RENESAS TECHNICAL UPDATE

Product Category	MPU & MCU	Document No.	TN-16C-A207A/E	Rev.	1.00
Title	Errata to R32C/121 Group Hardware Manual		Information Category	Technical Notification	
Applicable Product	R32C/121 Group	Lot No.	Reference Document	R32C/121 Group Hardware Manual Rev. 1.10 (REJ09B0477-0110)

This document describes corrections to the R32C/121 Group Hardware Manual, Rev. 1.10.
The corrections are indicated in red in the list below.

Figure 27.2 Addresses for ID Code Stored

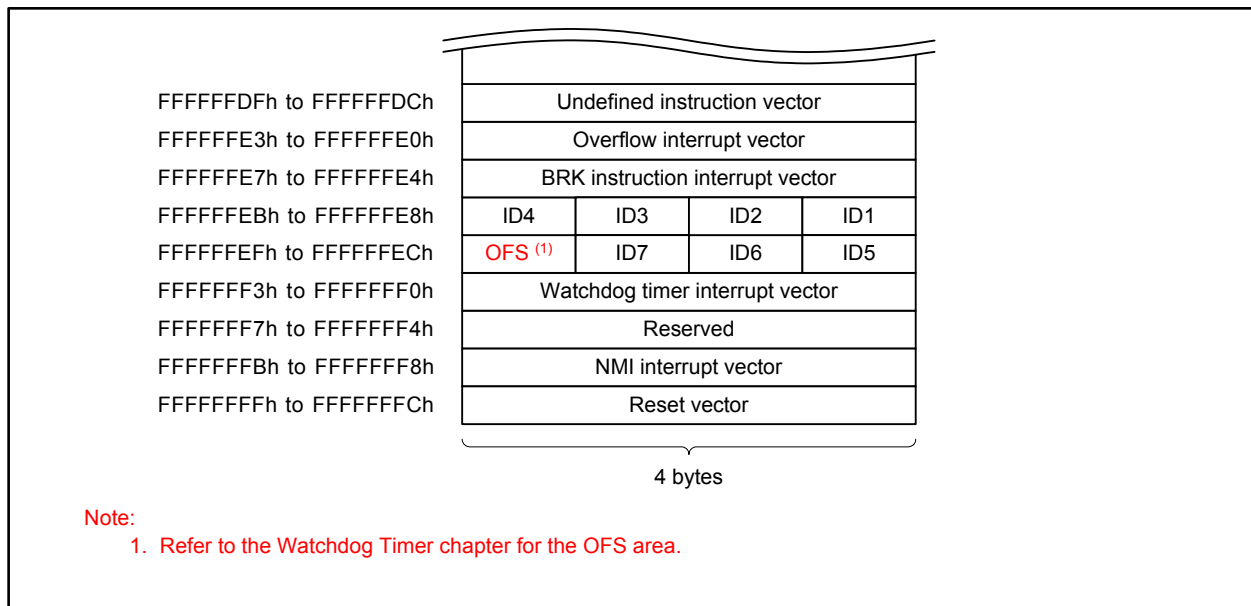
- Page 509 of 604, description “use the serial programmer to” is deleted from line 3 of 27.2.2.
- Page 510 of 604, Figure 27.2 is corrected as follows:

Figure 27.12 Read Timing

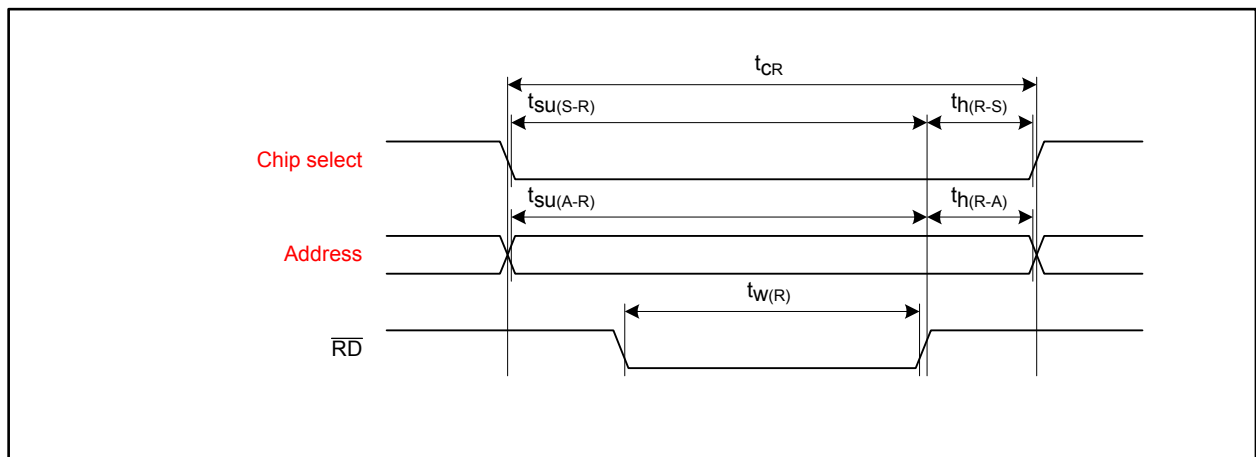
•Pages 518 and 520 of 604, descriptions in Figures 27.12 and 27.13 are corrected as follows:

Figure 29.5 Flash Memory CPU Rewrite Mode Timing

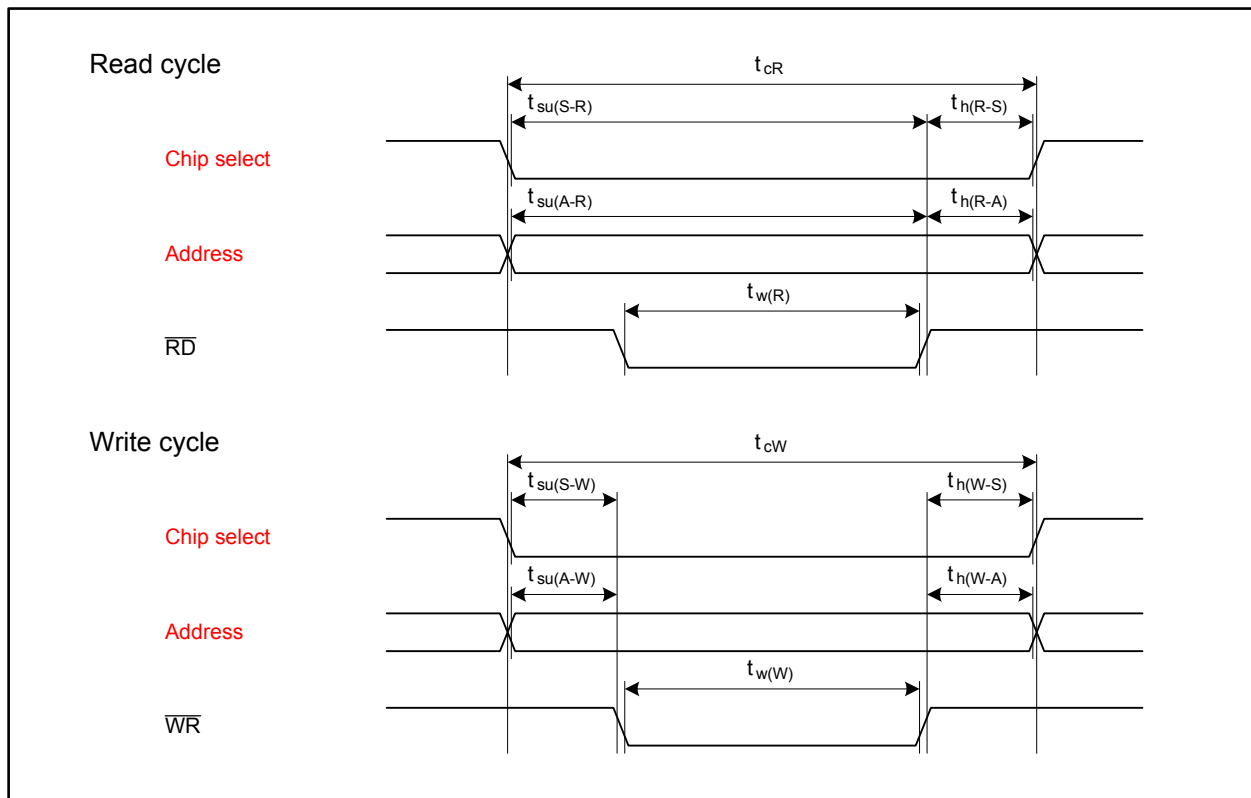
- Page 538 of 604, the following description is added to Note 3 of Figure 28.2:
 “However, the registers are not initialized.”
- Page 538 of 604, description “This mode setting prevents data from being overwritten if a program goes out of control.” is deleted from Note 5 in Figure 28.2.
- Page 544 of 604, description “EERR bit in the E2FS0 register is 1?” in Figure 28.12 is corrected as follows:
 “EERR bit in the E2FS0 register is 0?”
- Pages 553 and 554 of 604, description “Programming and erasure endurance of flash memory” in Tables 29.8 and 29.9 is changed as follows:
 “Program and erase cycles”
- Pages 553 and 554 of 604, unit “times” for “Programming and erasure endurance of flash memory” in Tables 29.8 and 29.9 and Note 1 is corrected as follows:
 “Cycles”
- Page 557 of 604, descriptions in Figure 29.5 are corrected as follows:
